# Access Compliance Report

## Public Rights-of-Way

Intersection ID: 45980	Main Street: LAUREL_VALLEY_RD	Cross Street: SHOPTON_RD	Location: SW
ADA ID: 01B3D398E4AA	Ramp Type: PerpDiag	Initial Pass/Fail: Fail	Overall Compliance: No
			Severity Score: 46.25

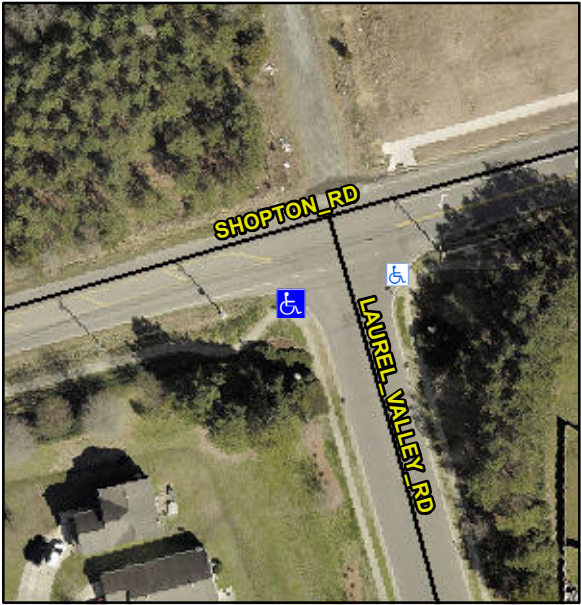
Codes/Mitigation Info/Possible Solution		Field Measurements/Component Compliance			
 <p>Street 1 Name LAUREL VALLEY RD</p> <p>Stop Condition-Street 2 StopSign</p> <p>Street 2 Name SHOPTON RD</p> <p>Stop Condition-Street 1 None</p>	<p>Possible Solutions:</p> <p><b>Remove &amp; Replace Curb Ramp With Two New Directional Ramps or Equivalent.</b></p> <p>Surveyor Notes:</p> <p><b>N/A</b></p> <p>PROW/ADA:</p> <p><b>Not Found, R304.5.1, R304.2.2, R304.5.3</b></p> <p>Total Cost: \$ 3200.00</p>	Compliance	Description	Data	
		N/A	Ramp Length (in)	47.0	No
		No	Ramp Width (in)	42.0	No
		N/A	Flare Type LT	N/A	N/A
		N/A	Flare Slope LT (%)	N/A	N/A
		N/A	Flare Traversable LT?	N/A	N/A
		N/A	Landing Length (in)	N/A	N/A
		N/A	Landing Width (in)	N/A	N/A
		N/A	Landing Slope (%)	N/A	N/A
		N/A	Landing X Slope (%)	N/A	N/A
		N/A	Landing Curb? (Y/N)	N/A	N/A
		N/A	Shared Landing?	N/A	
		N/A	Gutter Ponding?	N/A	N/A
		N/A	Gutter Lip Ht (in)	N/A	N/A

N/A	Painted X Walk1?	No	N/A
			X Walk 1 Direction	To E	
		N/A	X Walk 1 Width (in)	N/A	N/A
			X Walk 1 Slope (%)	7.8	
			X Walk 1 X Slope (%)	4.8	
		N/A	Ramp inside XWalk1?	N/A	N/A
			Road Slope (%)	6.7	N/A
			Road X Slope (%)	5.6	N/A
		N/A	Any Obstructions?	N/A	N/A
			Obstruction Type		
				N/A	N/A
				Yes	Surface Condition? (G/P) Good
